# Review Assessment

Wilmington Harbor, North Carolina  
Navigation Improvement Project  
Integrated Section 203 Study & Environmental  
Report  
(February 2020)

May 2020

**Table 9-6: Tidal Datum Absolute Changes**

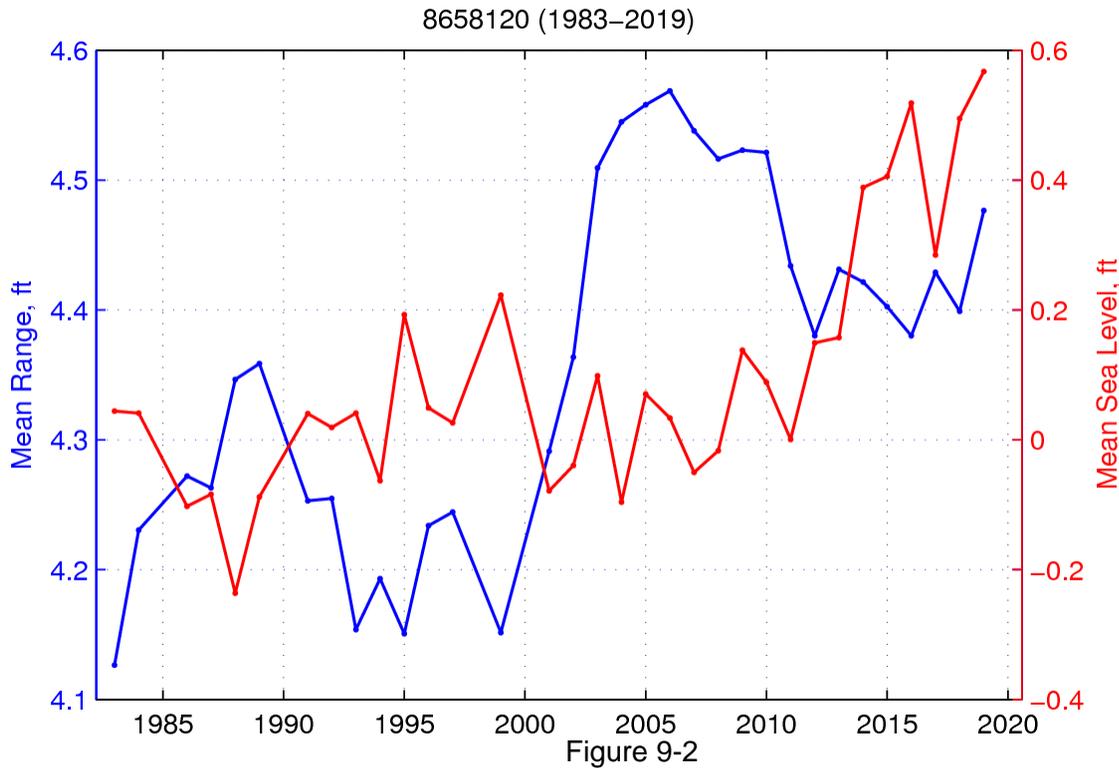
Table 9-6 shows a notable change in the mean tide range as a result of the channel improvements that occurred between 2000 and 2004. This is especially clear in Figure 9-2 based on yearly data. Figure 9-2 a significant but gradual increase in the tidal range which occurred between 2000 and 2004 due to the most recent channel deepening / widening project.

OASACW/HQUSACE Final Assessment: The comment is unresolved. In particular, the response states that “The change in tidal range is not due to climate effects, but rather due to the alteration of the Cape Fear River Estuary by federal navigation projects over the past 150 years. Thus, this trend in MHHW (and tide range) should not be expected to continue in the future in the absence of any future navigation projects and should not be used as the future sea level for the FWOP and FWP conditions.” In fact, this project will exacerbate the situation by deepening the channel further with potential nonlinear increases in tidal prism upstream. Risks to shoreline development, bridge clearance, if any, coastal flood risk reduction measures, if any, and the performance of gravity drainage infrastructure, should be addressed. . Where these systems were federally-funded in whole or in part, this project cannot reduce their design performance. A description of the potential issues and any necessary adaptation measures is sufficient.
